REGIONAL REVIEW FINDING

ARC REVIEW CODE: R1208242

Name of Proposal: Chastain Mixed-Use
Submitting Local Government: City of Sandy Springs

Review Type: Development of Regional Impact
Date Opened: Aug 24 2012

Sheet No. PSP.007

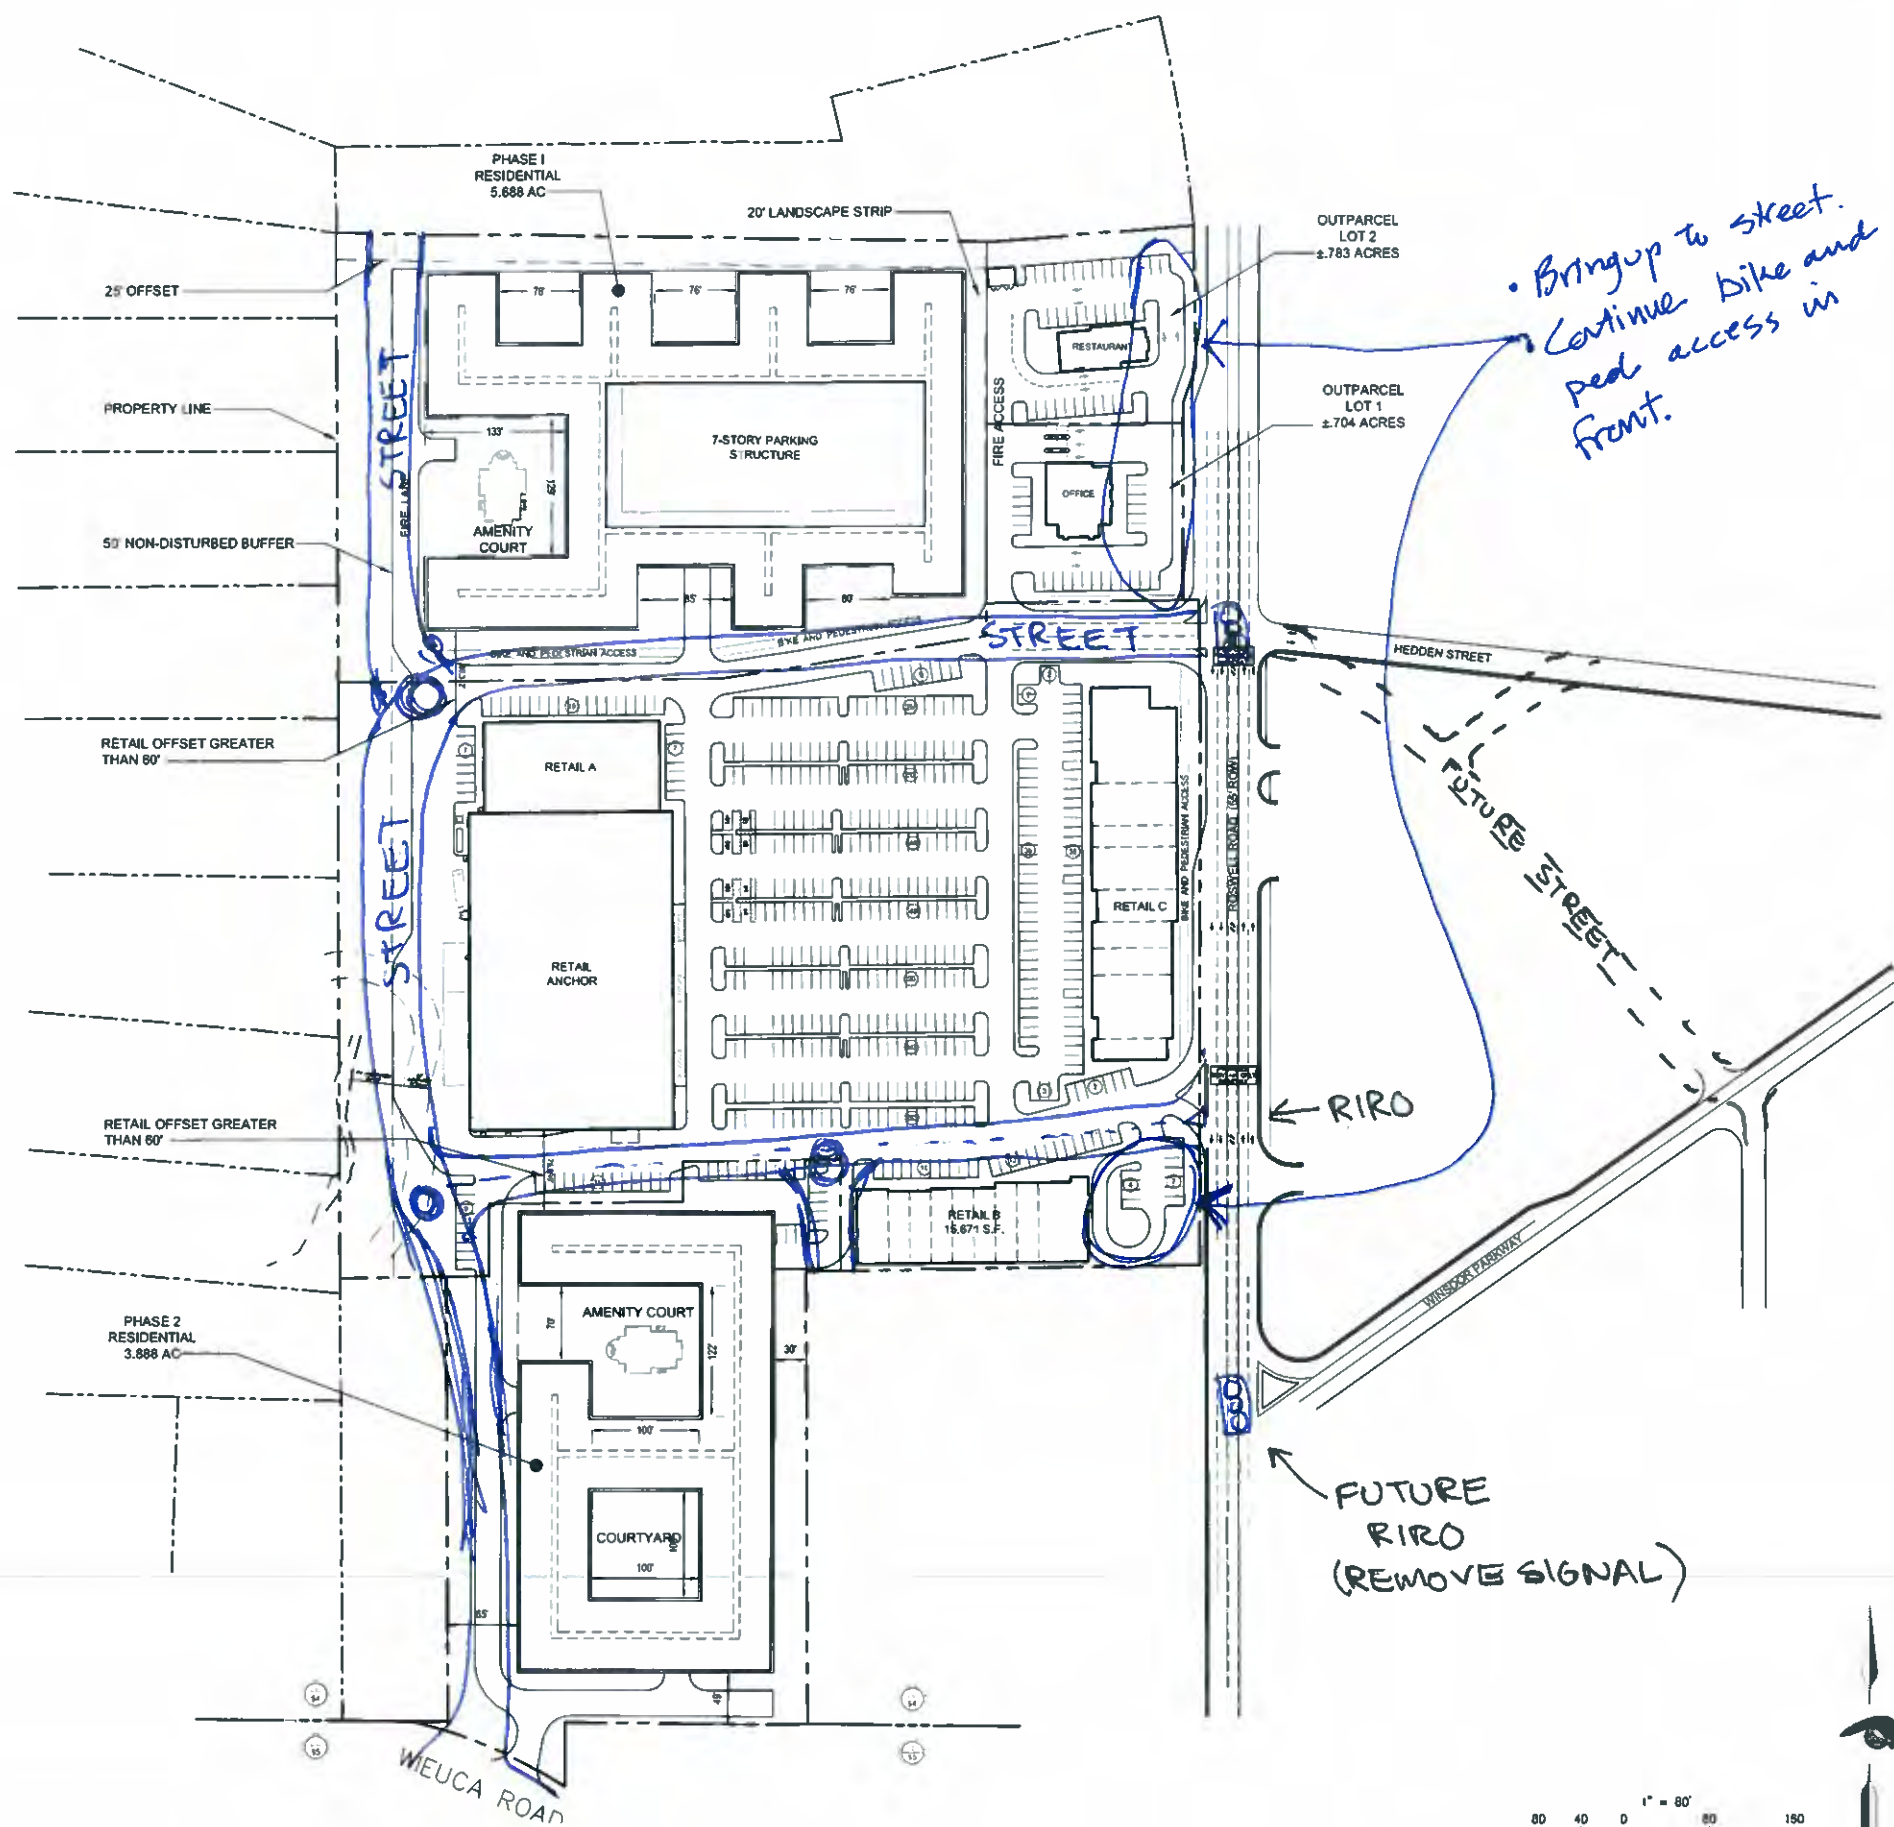
The City of Atlanta Transportation Planning Division staff has reviewed the site plan and preliminary report for [DRI #2290 Chastain Mixed-use](#) and we offer the following comments (also noted on attached mark-up of site plan). We recognize that most of this site is located outside the City of Atlanta city limits. However, we believe that trips to and from this development will terminate within the City of Atlanta and that many of these trips will impact the roadway network within the City of Atlanta.

- Development should include a complete urban street framework connecting Roswell Road (US 19/SR 9), West Wieuca Road and abutting commercial parcels along Roswell Road (US 19/SR 9). This street network should include horizontal traffic calming measures (i.e. roundabouts, chicanes, chokers, etc.) to control motor vehicle operating speeds and regulate traffic volumes. This street network is essential for the even distribution of trips and will greatly mitigate impacts to the intersection of Roswell Road (US 19/SR 9) and West Wieuca Road. The access to West Wieuca Road as currently designed is cumbersome, inadequate and will be difficult to navigate. This will create circulation and congestion issues.

- Buildings fronting Roswell Road (US 19/SR 9) should be moved closer to the street with all parking located behind the plane of the building façade. This will create an environment much more conducive to bicycling, walking and riding transit.

- Sidewalks should be constructed along all property frontages and clear and level walkways should connect the sidewalks to the building entrances within the development.

- As West Wieuca Road is designated as a Secondary Bicycle Connection in the *Connect Atlanta Plan*, the entrance to the development from West Wieuca Road should include provisions for bicyclists (i.e. bicycle boxes, bicycle lanes, bicycle ramps, signage for bicycle parking, etc.).

- As Roswell Road (US 19/SR 9) is designated as a Secondary Bicycle Connection in the *Connect Atlanta Plan*, we would recommend that a southbound on-road five-foot-wide bicycle lane be installed along the property frontage.

- As Roswell Road (US 19/SR 9) is designated as a bus rapid transit corridor in the *Concept3 Regional Long-Range Transit Vision* and *Connect Atlanta Plan*, we would recommend that the developer coordinate closely with MARTA staff to locate/relocate transit amenities (i.e. bus stop pads, benches, shelters, signs, queue-jump lanes, etc.) along the property frontage.

Figure 1

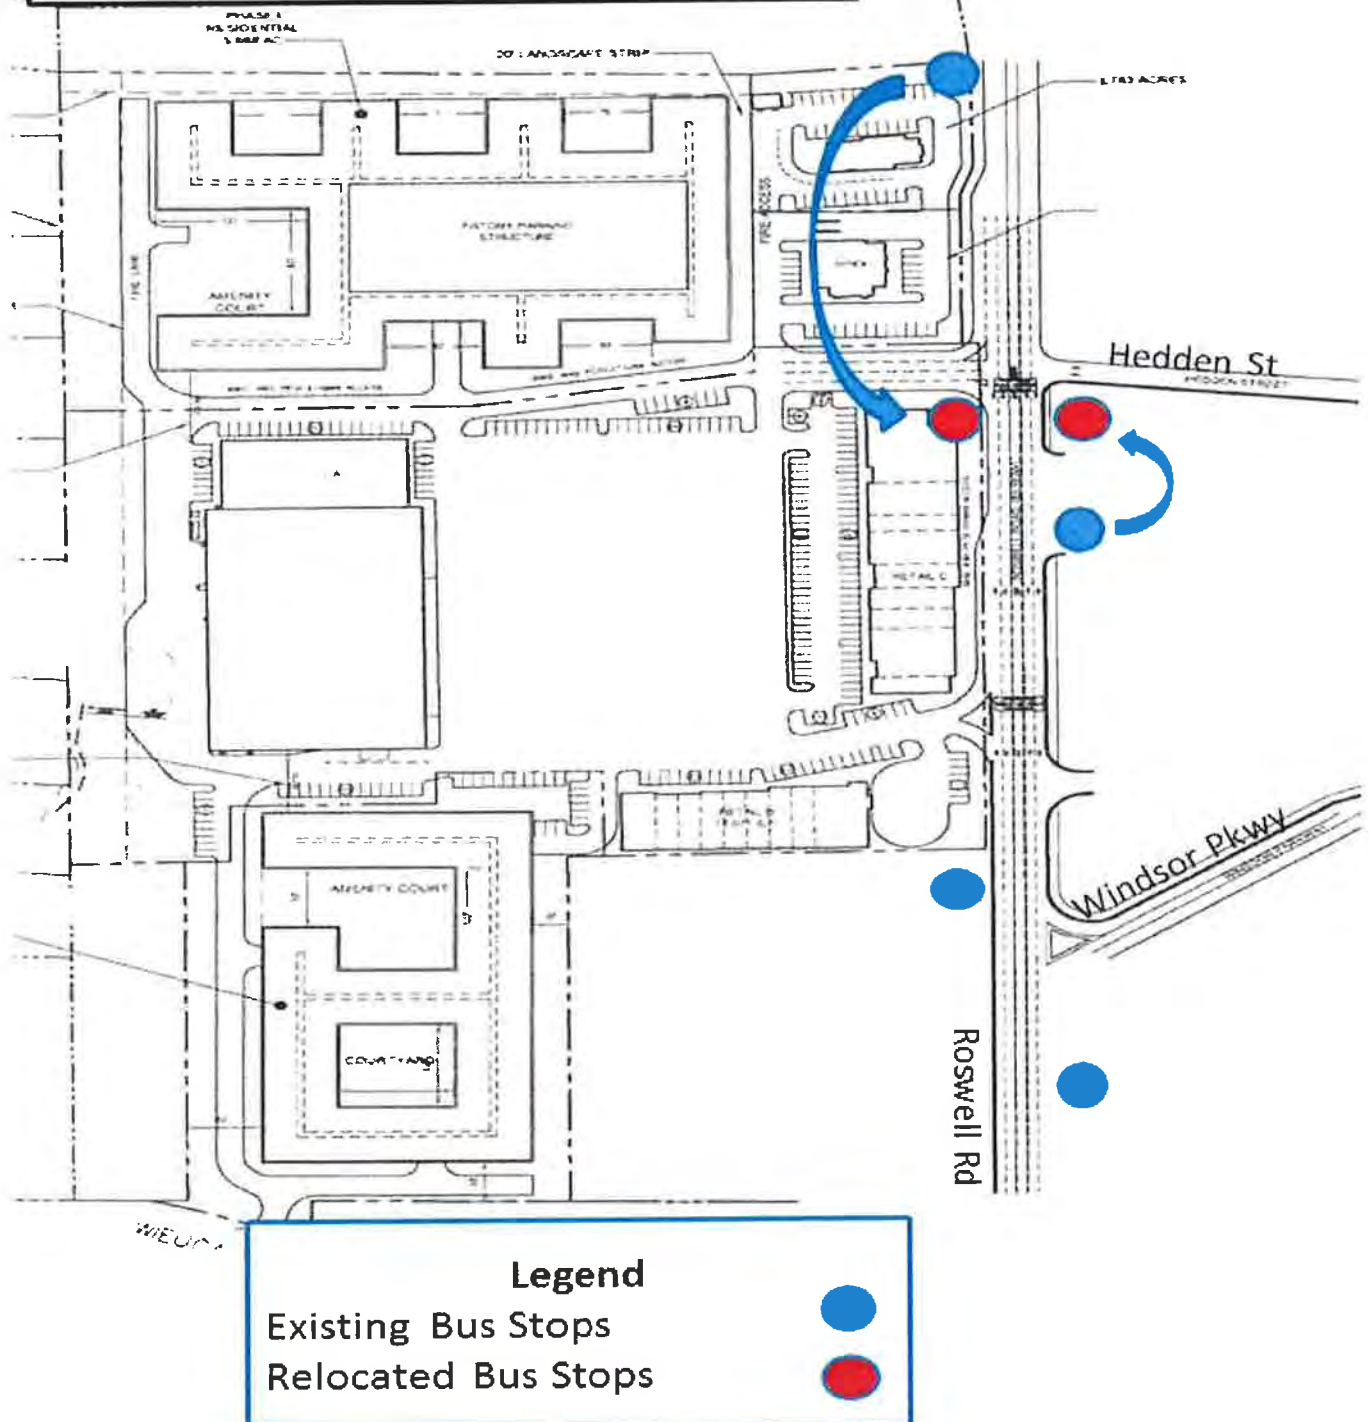
However, MARTA is concerned with transit patron accessibility and safety. There are a total of four bus stop signs that are in close proximity to this development. Two of those stops front along the same side of Roswell Road as the proposed development. An examination of the site plan revealed that there is a need for changes to the placement of bus stops in order for MARTA patrons to have better access to the new development. The site plan indicates that the main entrance to the development is located between the two existing bus stops. The closest stop to the main entrance is estimated to be a distance of 400 feet to the north. While this is not an unreasonable walking distance; there is little reason why the bus stops in the area cannot be repositioned for greater pedestrian access to the new development.

Our suggestions in this matter are illustrated in the attached Figure 1. The first stop that should be relocated is near the northern portion of the existing apartment complex entrance. According to the site plan there would be no curb cut or designated pedestrian access at this location. We recommend that this stop be relocated near the main entrance. The second stop that is recommended for relocation is across Roswell Road just south of Hedden Street. We recommend that this stop be relocated approximately 180 feet from its current position to the north closer to Hedden Street. This relocation will align the bus stops. In addition to the bus stop alignment at Hedden Street, we recommend improved pedestrian crossing facilities be included in the intersection improvements.

Sheet Title PRELIMINARY
SITE PLAN

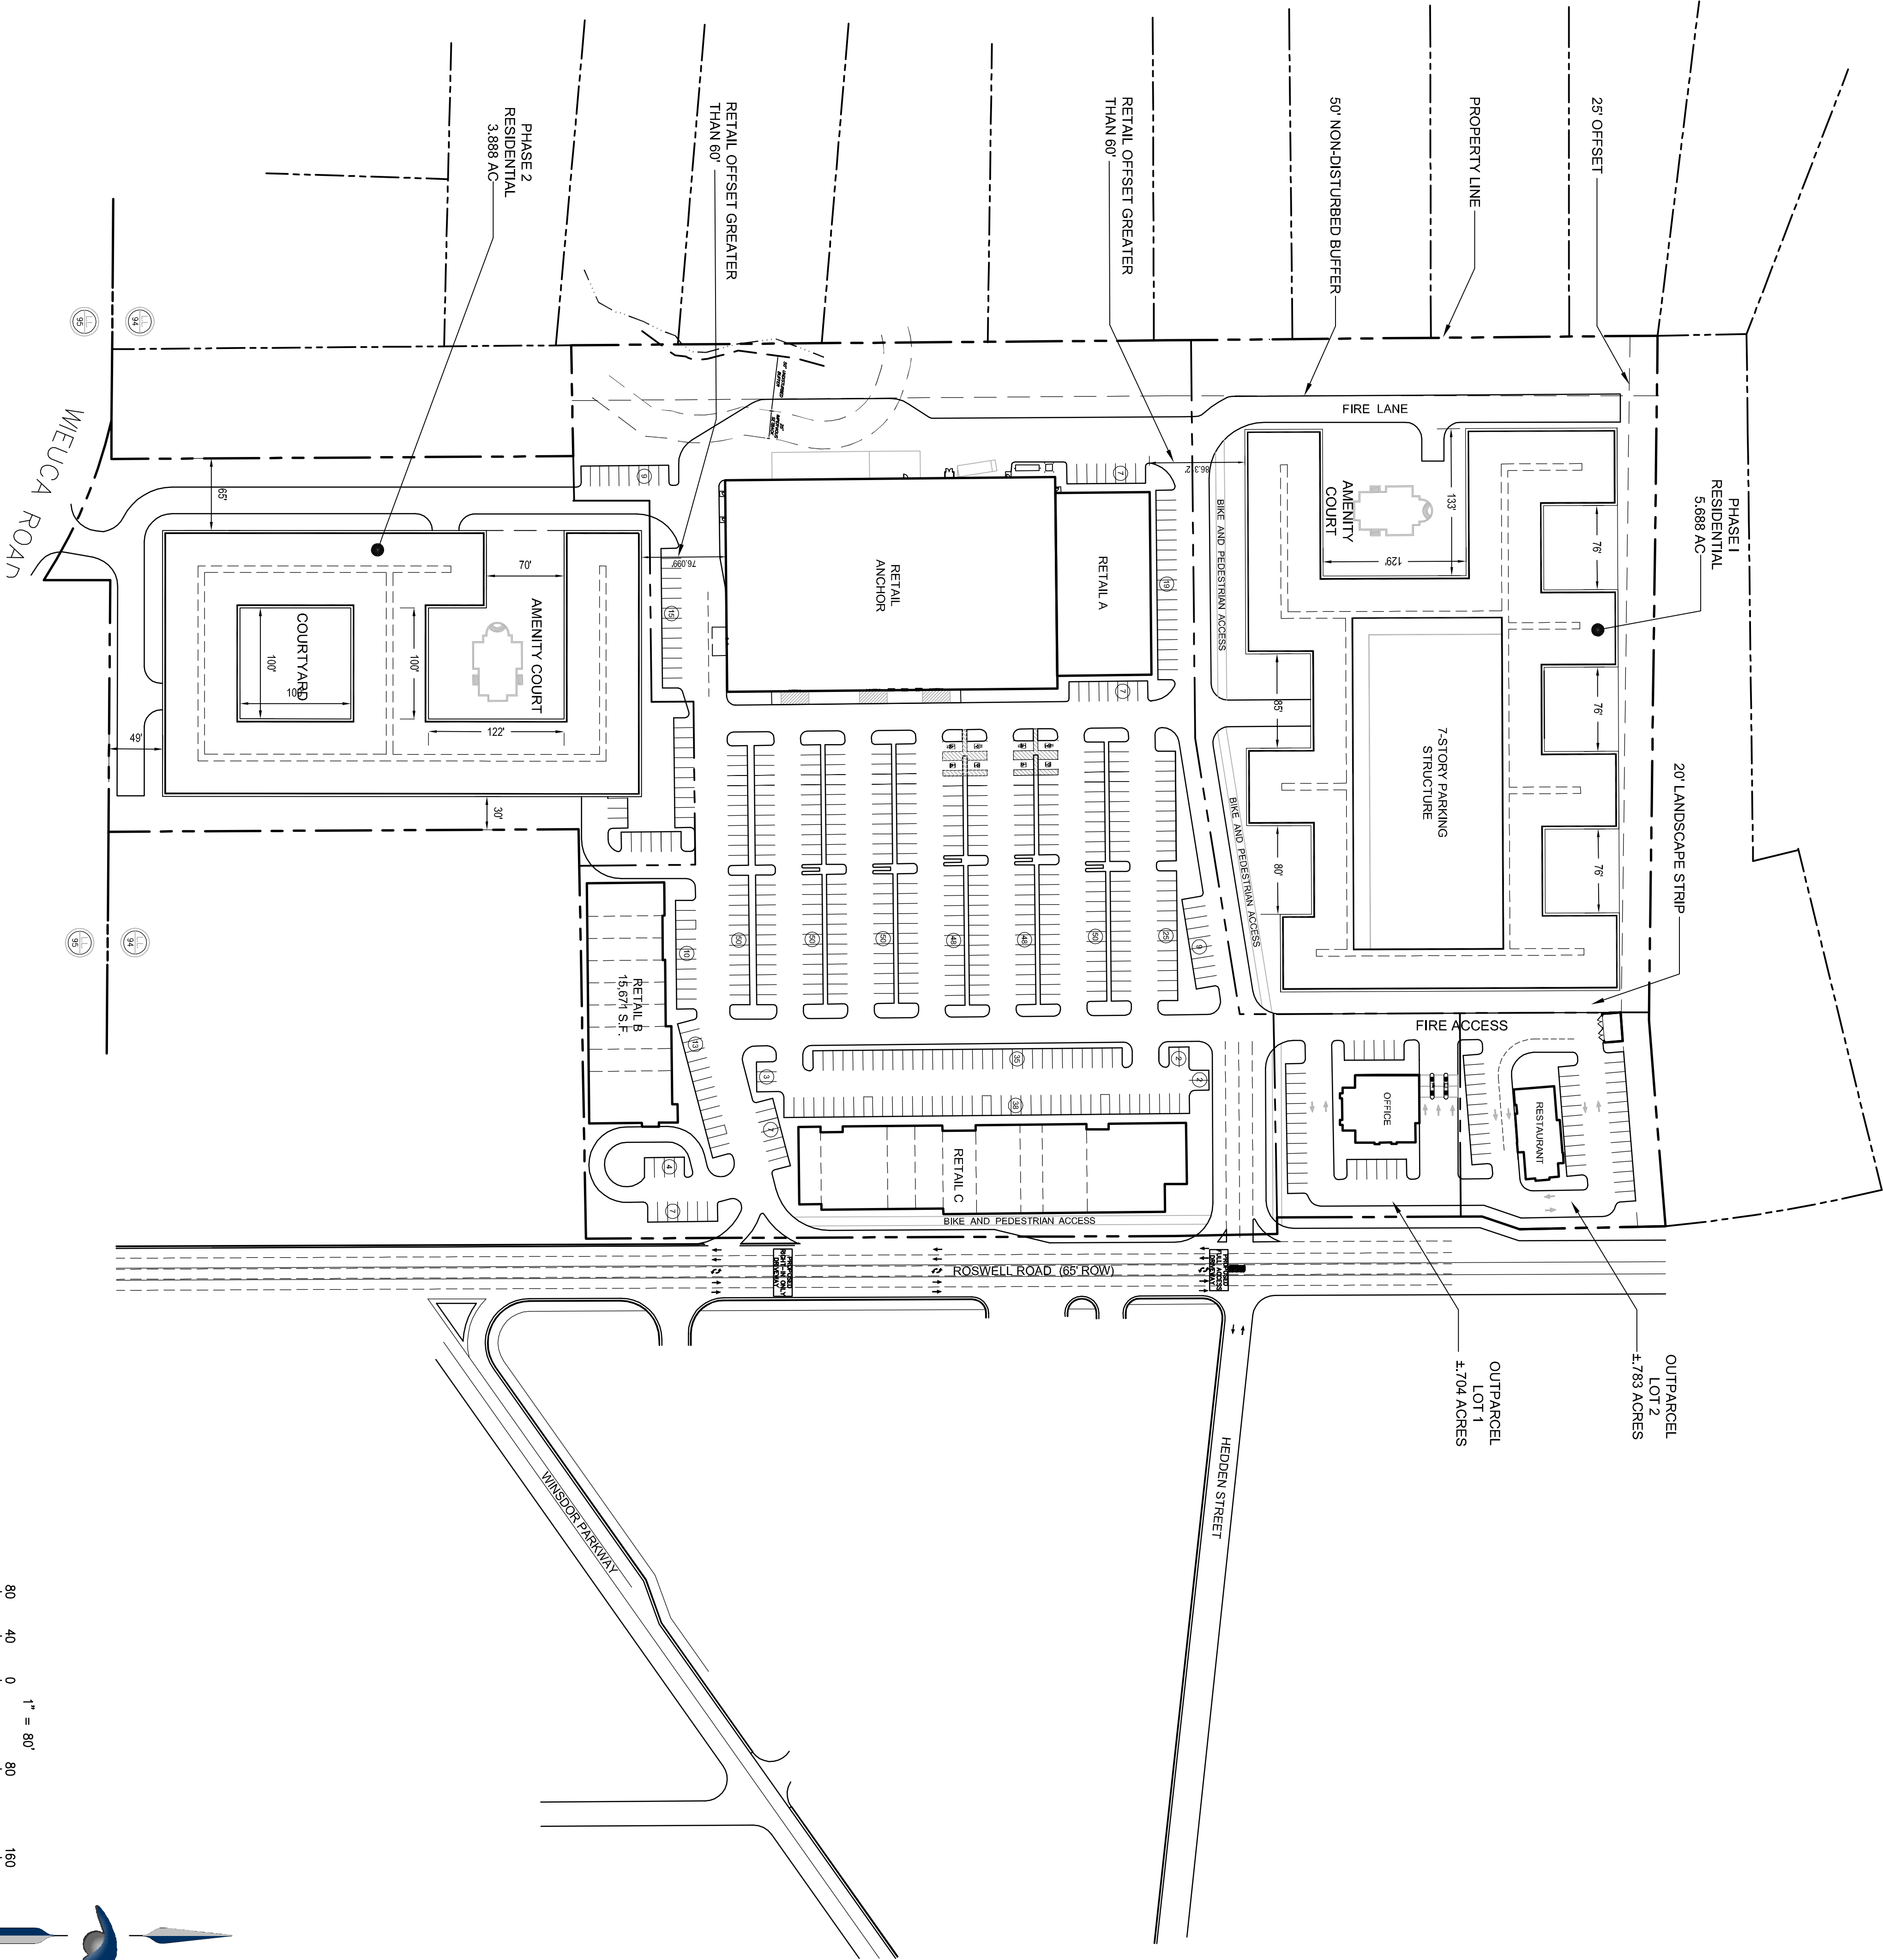
- The site plan presented during the pre-application meeting on July 30th, 2012 shows "Bike and Pedestrian Access" along Roswell Road in front of the "Retail C" building and not the entire frontage of the site. The developer should continue bike and pedestrian access along the entire Roswell Road frontage of the site.

- Inner-site connectivity and internal circulation is of concern. The site plan shows the center of the development as a large parking lot with no pedestrian facilities. Pedestrians need to be able to travel safely between uses/buildings within the site.

- Safe crossings should be maintained at Roswell Road and Windsor Parkway NE and pedestrian appropriate infrastructure should be installed at the new full access intersection of Hedden Street and Roswell Road to ensure pedestrian safety.
